SERVICE BULLETIN

No.**292 73 2092**

ARRIEL 2 B - B1 - C - C-PM - C1- C2 - S1

Subject: Hydromechanical Metering Unit (HMU). LP fuel pressure switch with dual sealing diaphragm.**Application of modification TU 92.**

ANNEXE 2 / APPENDIX 2

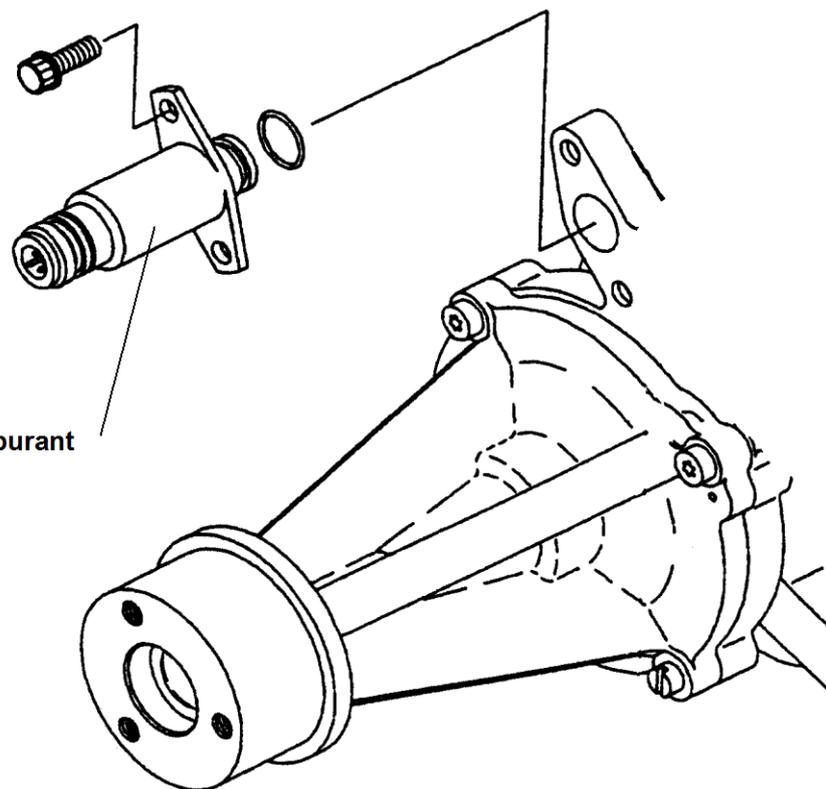
C. Description (see appendix 2)

This modification consists of installing a new LP fuel pressure switch. This new switch has undergone the following improvements:

- addition of a restrictor in the adjusting screw,
- application of a dual sealing diaphragm.
